This Addendum is hereby made a part of the Contract Documents to the same extent as though it were originally included therein.

END OF ARCHITECTURAL ADDENDUM NO. 1

SALK MIDDLE SCHOOL GYMNASIUM REPLACEMENT

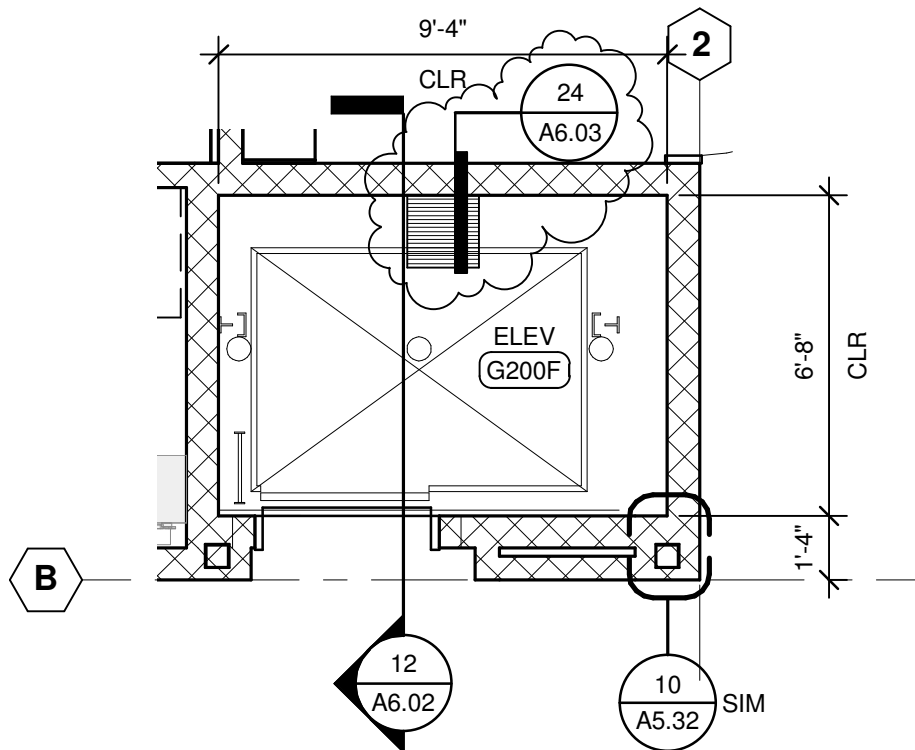
SHEET A6.03, STAIR DETAILS:
ADD: Detail 24 as shown on Drawing CA-02.

CA-01

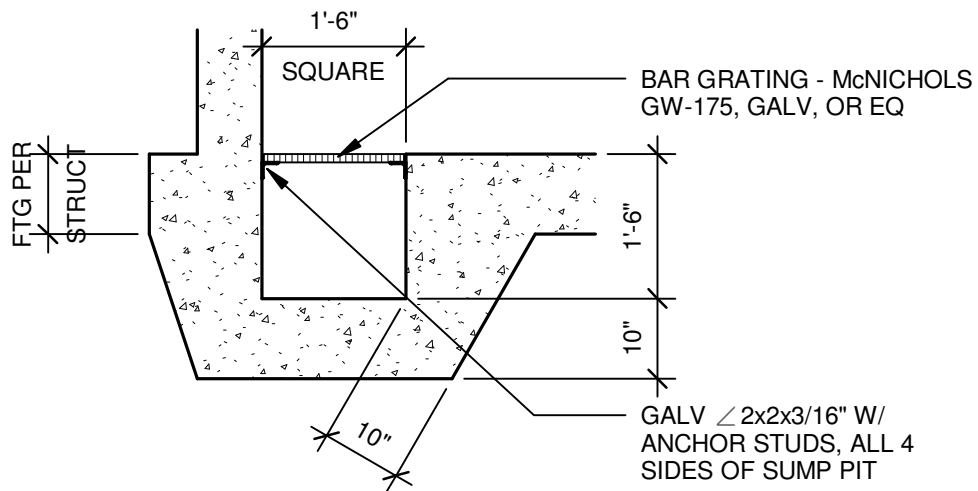
SHEET A6.02, ENLARGED WEST STAIR PLANS AND SECTIONS, Enlarged Plan 3:
ADD: Dry sump in elevator pit as shown on Drawing CA-01.

CA-03

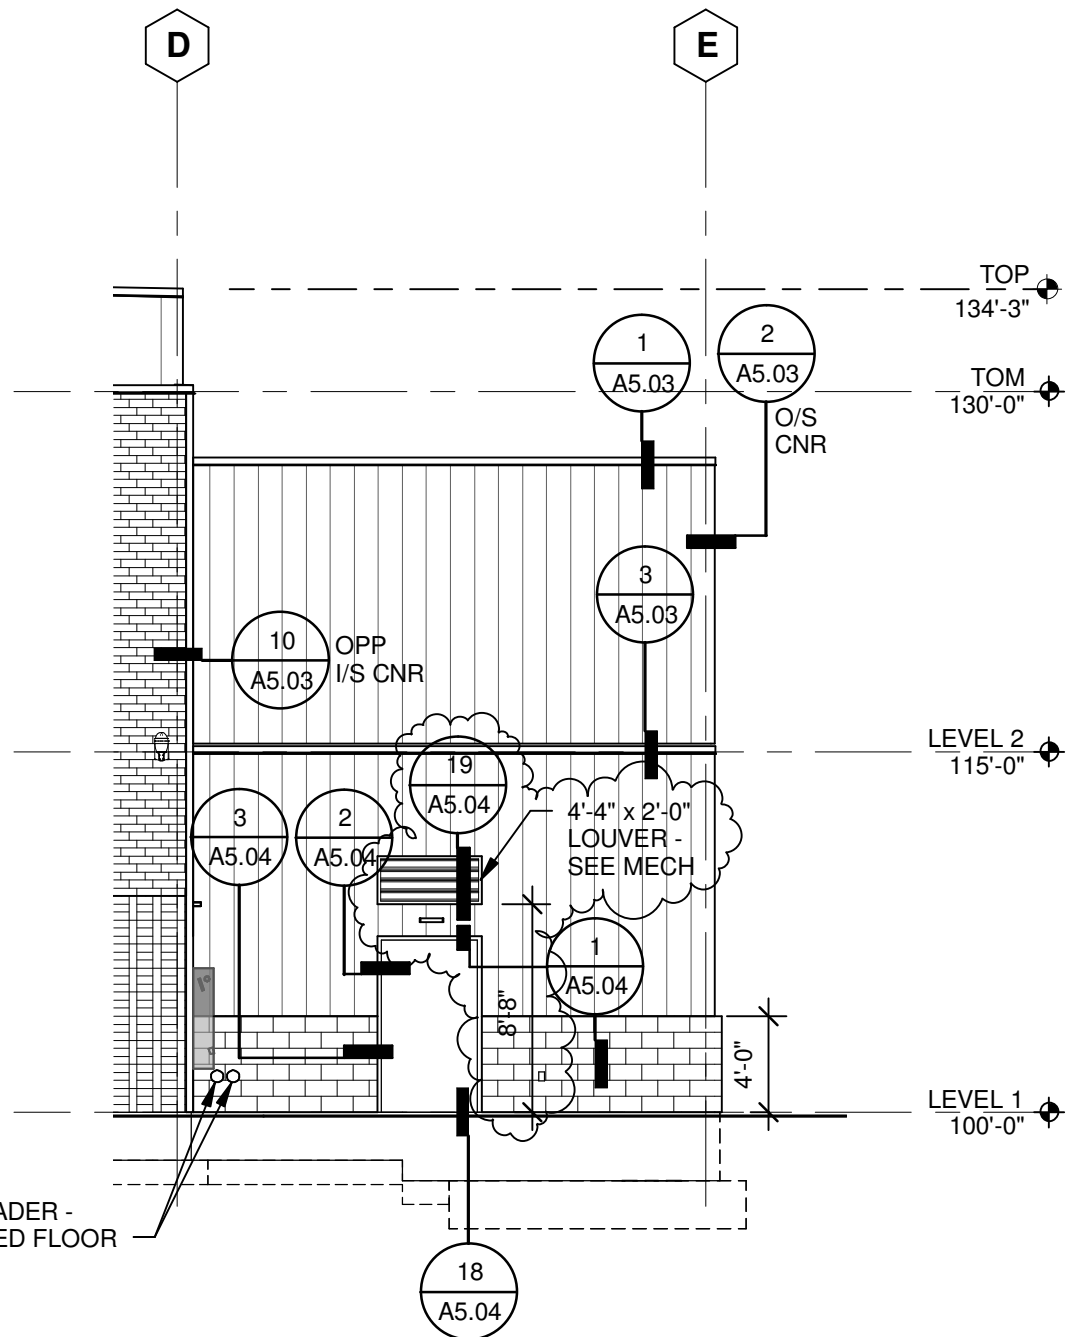
SHEET A4.01, EXTERIOR ELEVATIONS, Elevation 7:

ADD: Louver over Door 001A as shown on Drawing CA-03.

CA-04

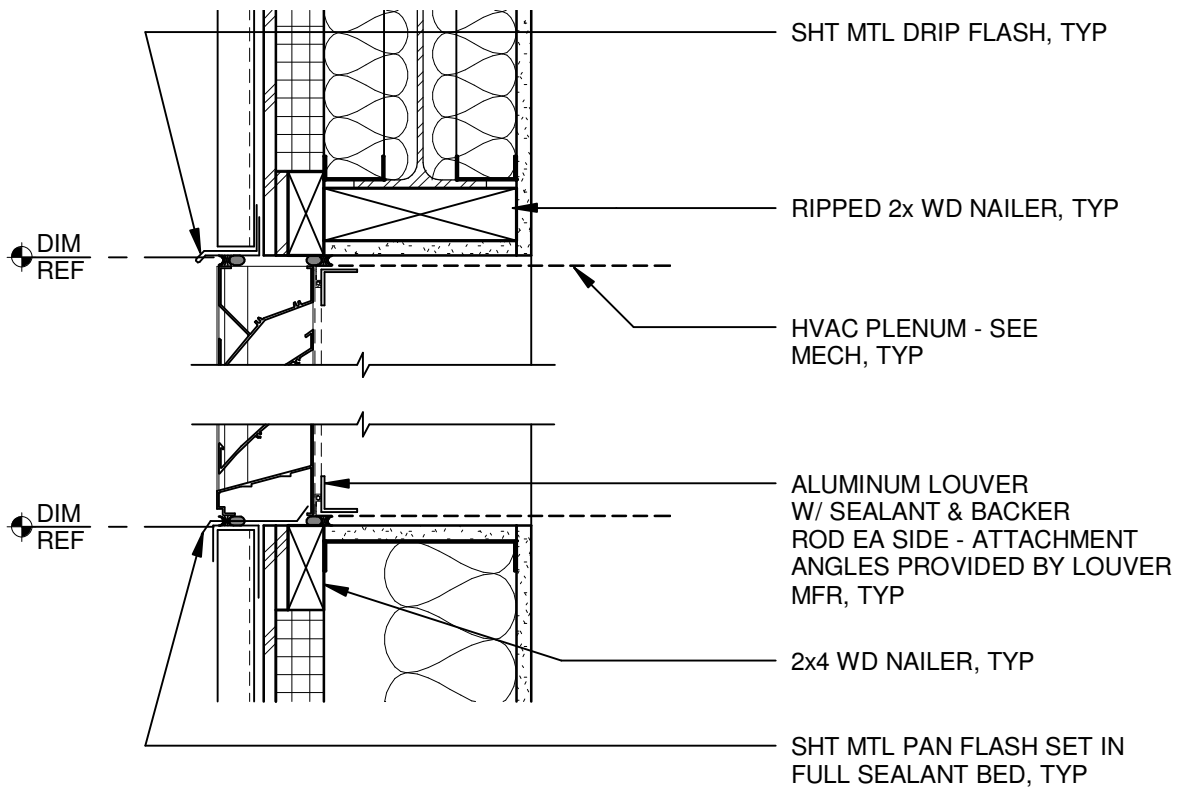
SHEET A5.04, EXTERIOR DETAILS:

ADD: Detail 19 as shown in Drawing CA-04.

CP-01

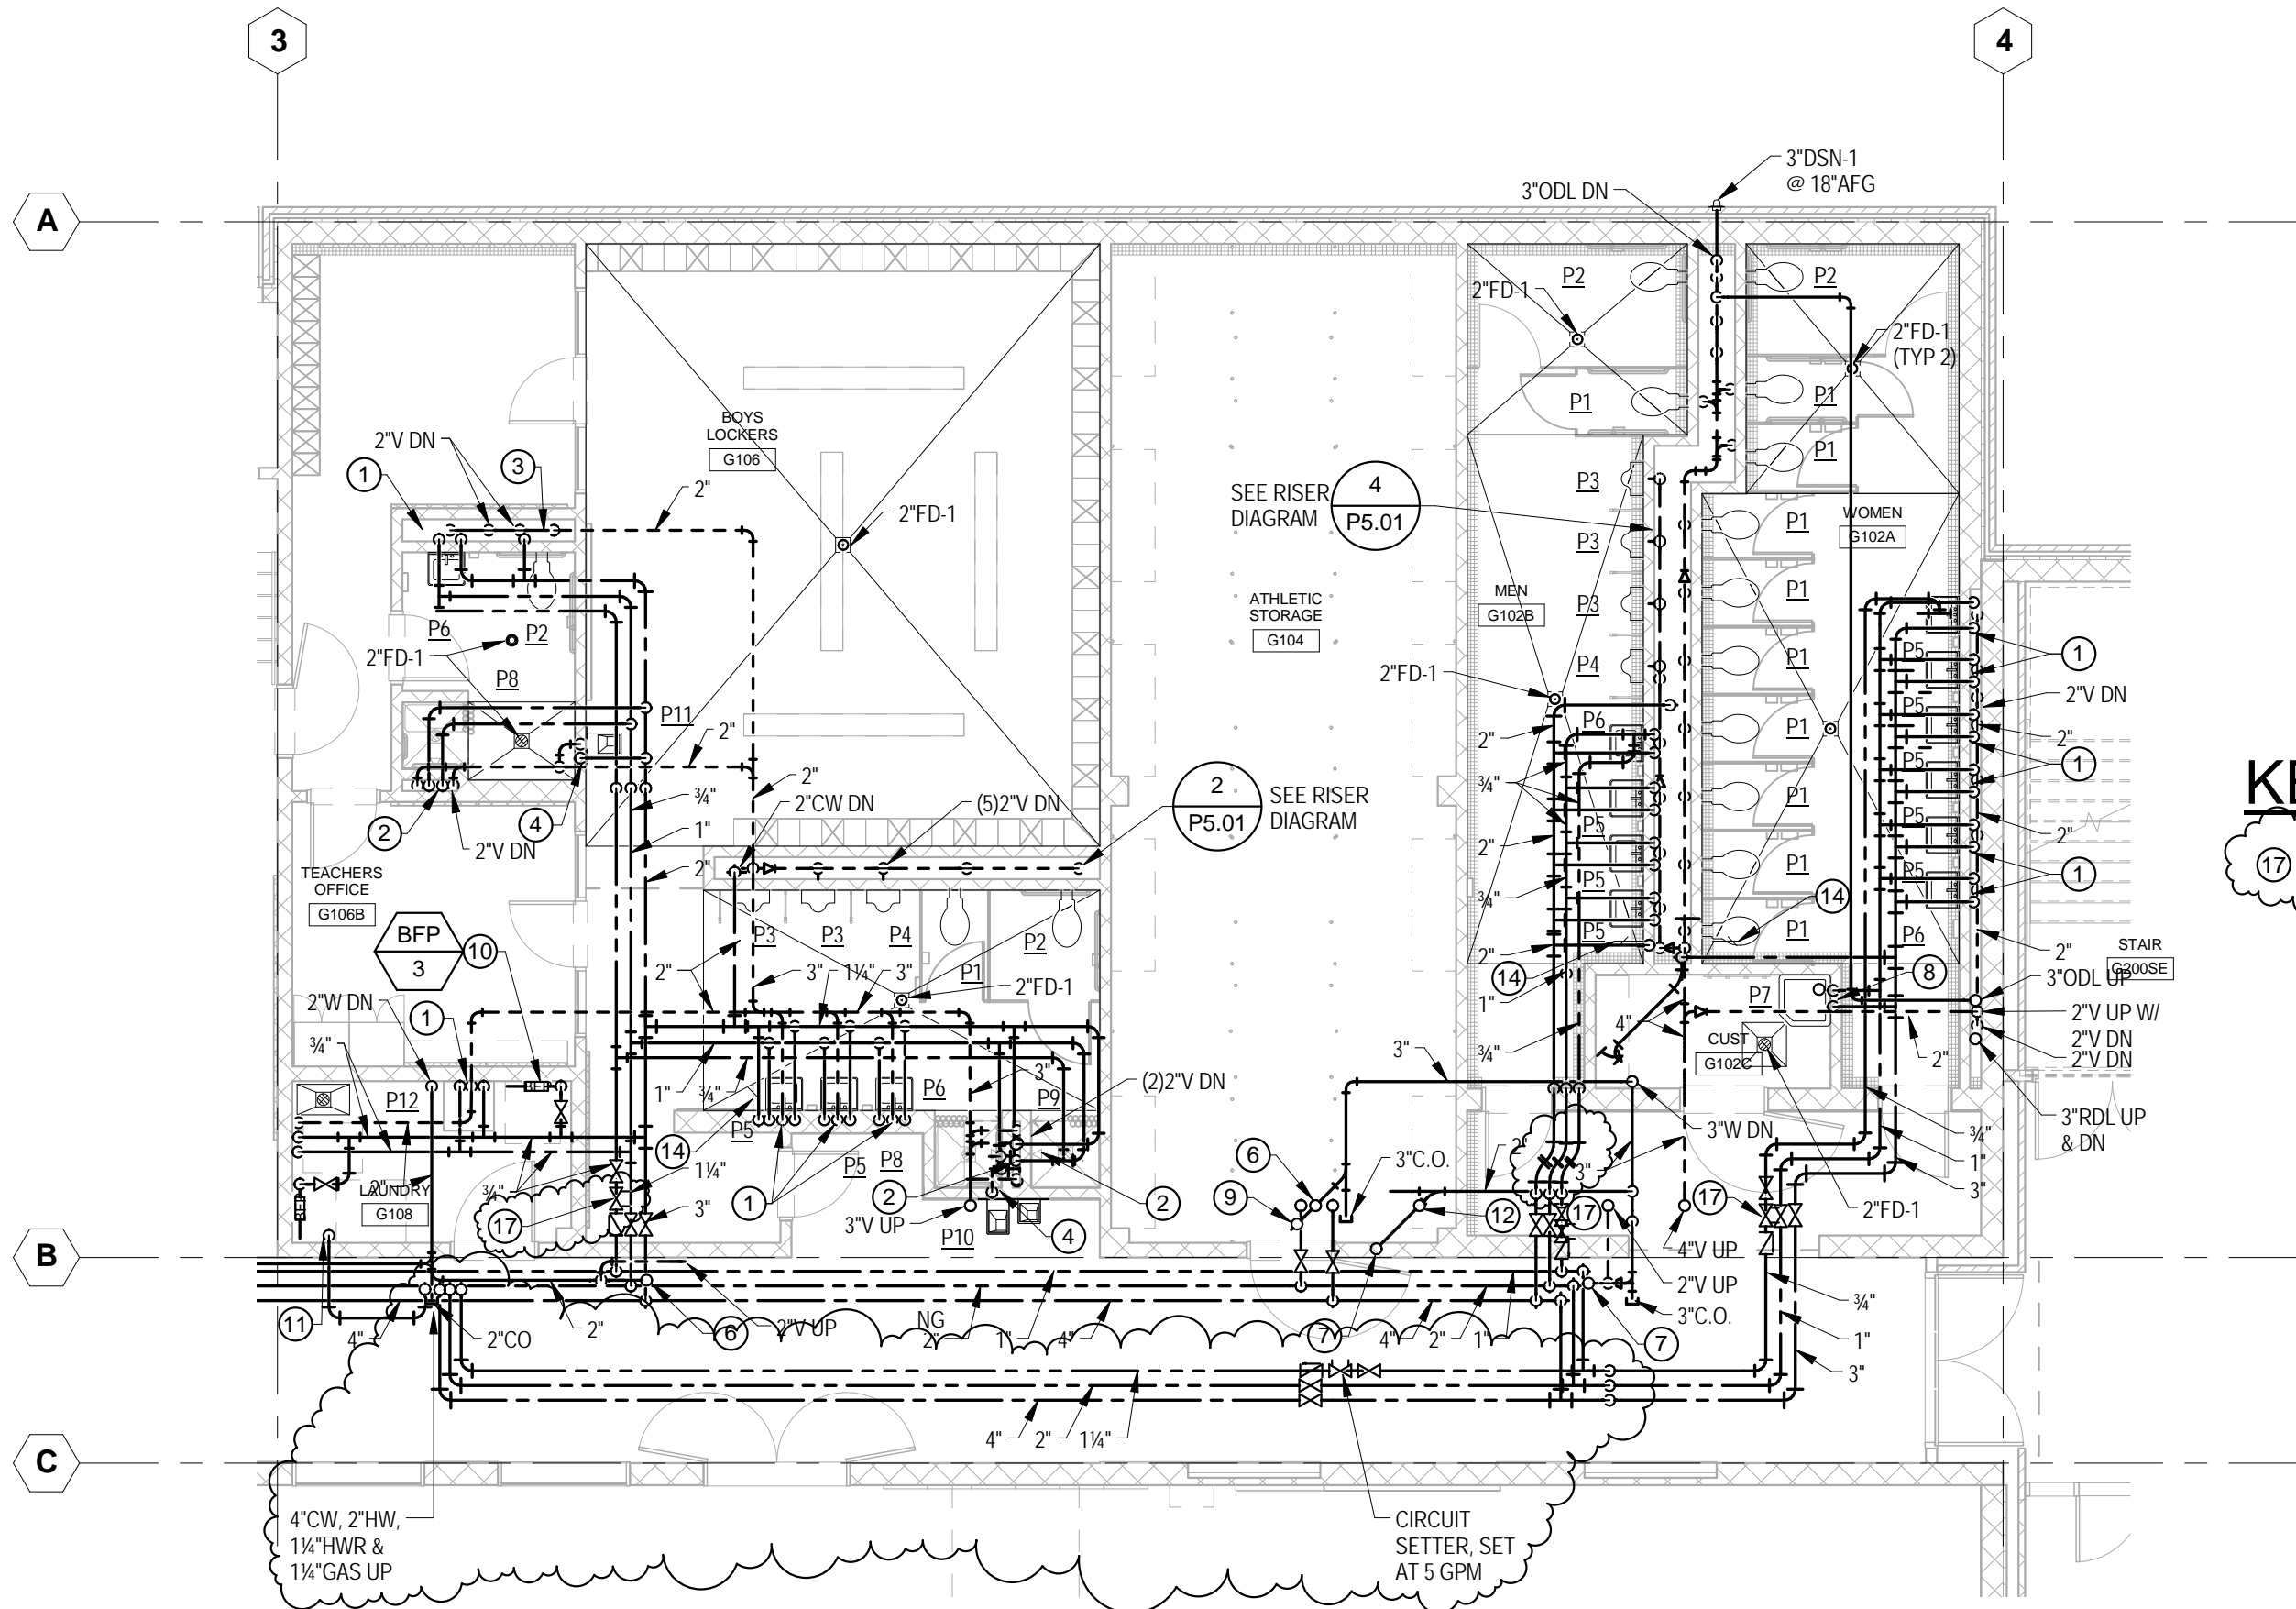
REVISE: Domestic water supply routing in the north side of the gym in the corridor see sheet CP-01 & CP-02.

ADD: Isolation valves at locker rooms. See sheet CP-01& CP-02.

ADD: Circuit setter call out – key note. See Sheet CP-01&CP-02.

CP-03

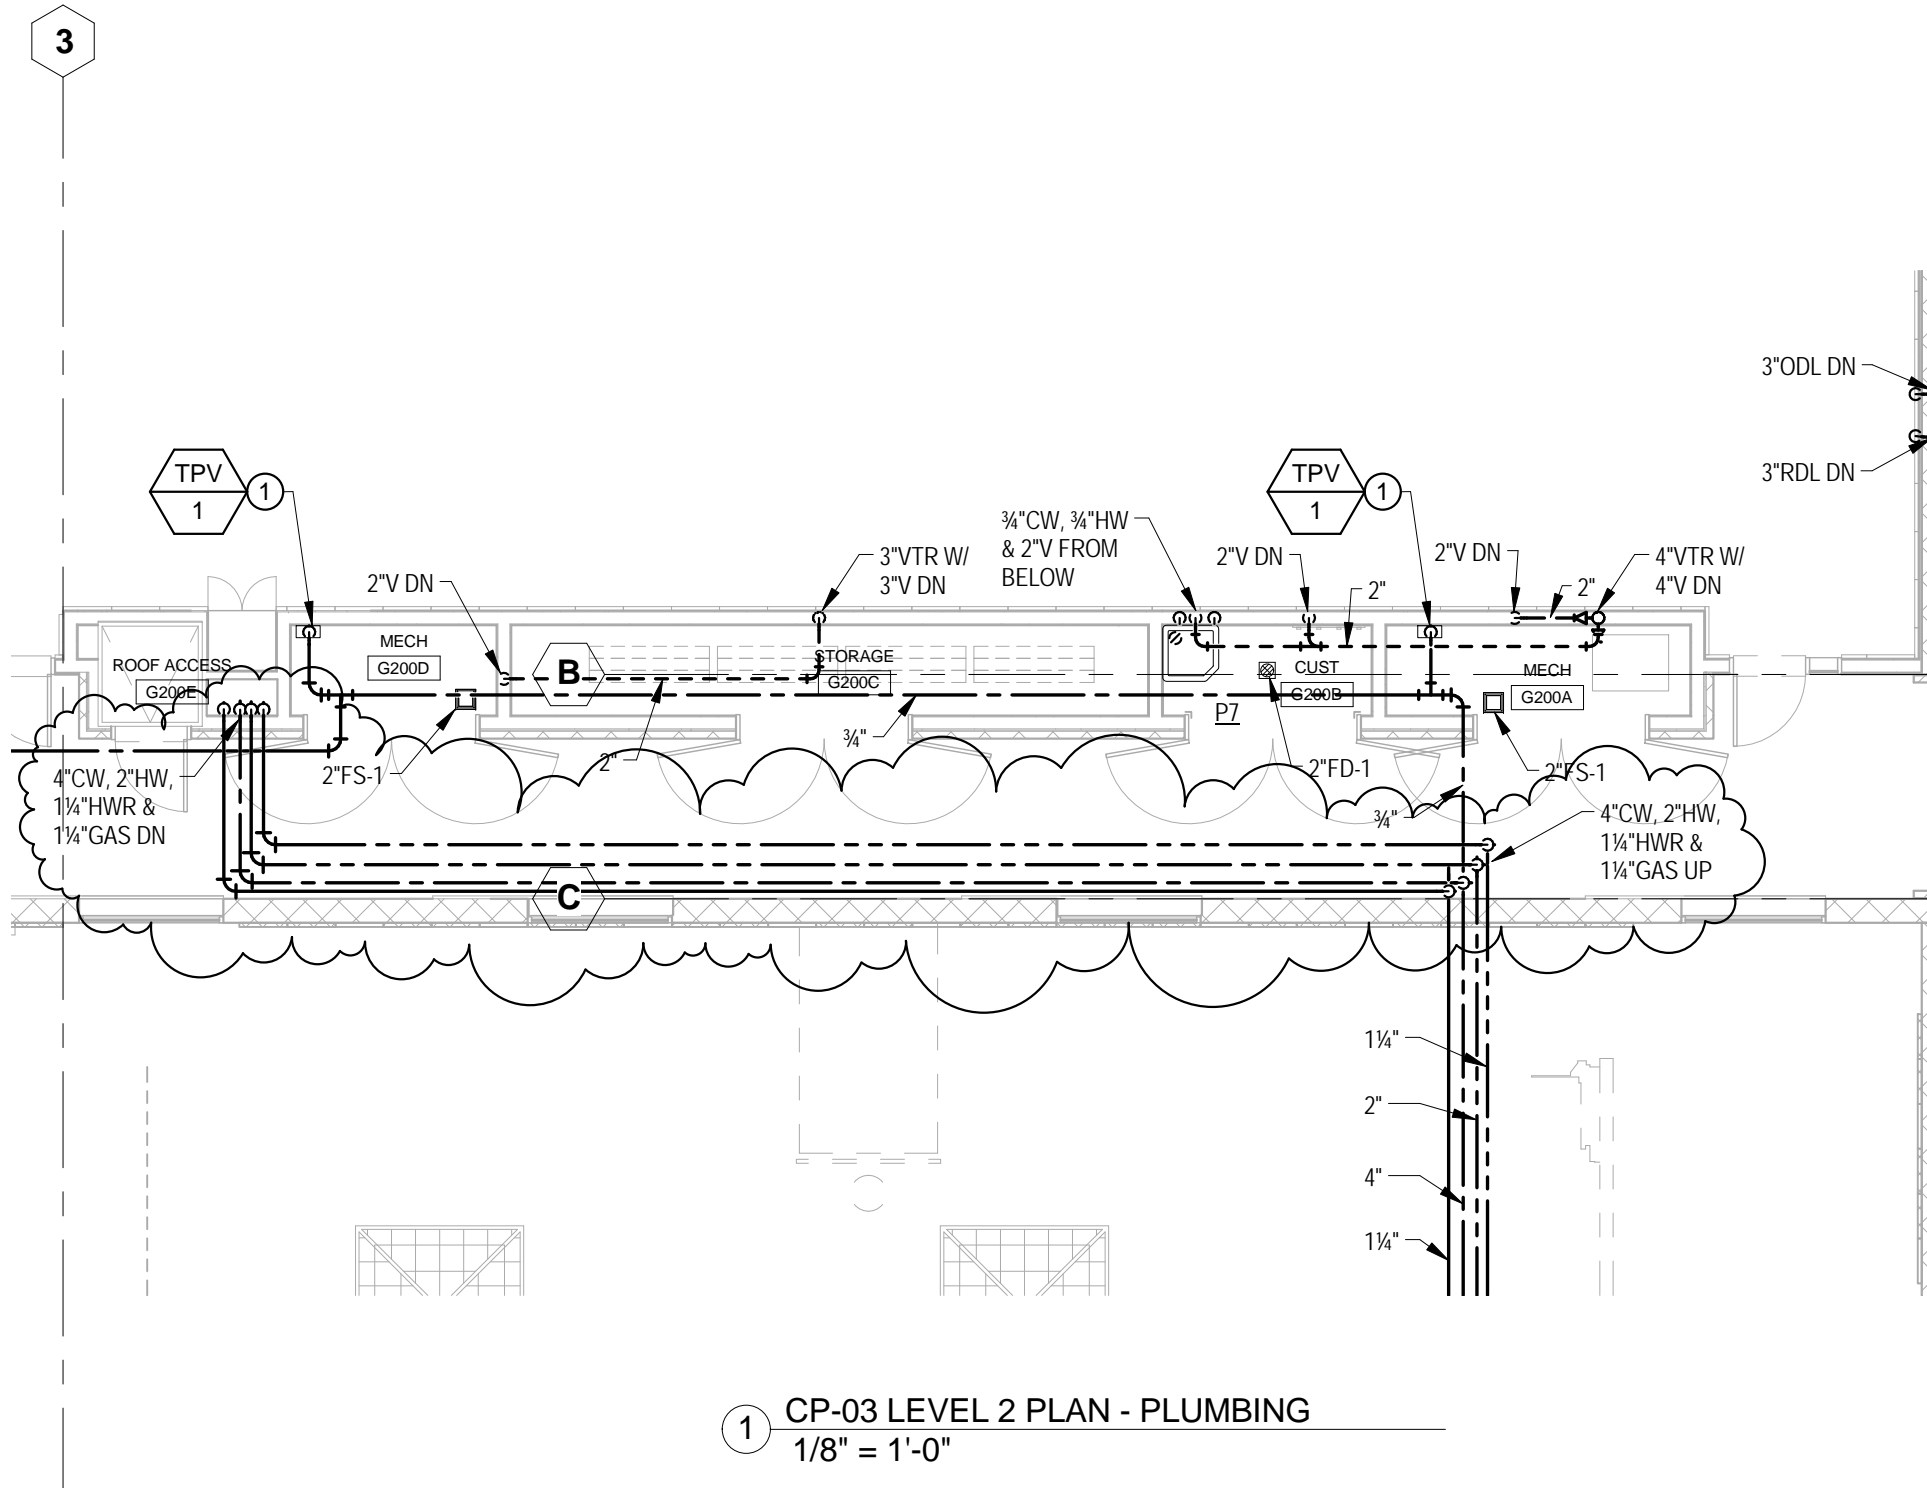
REVISE: Domestic water supply routing in the north side of the gym in the corridor see sheet CP-03
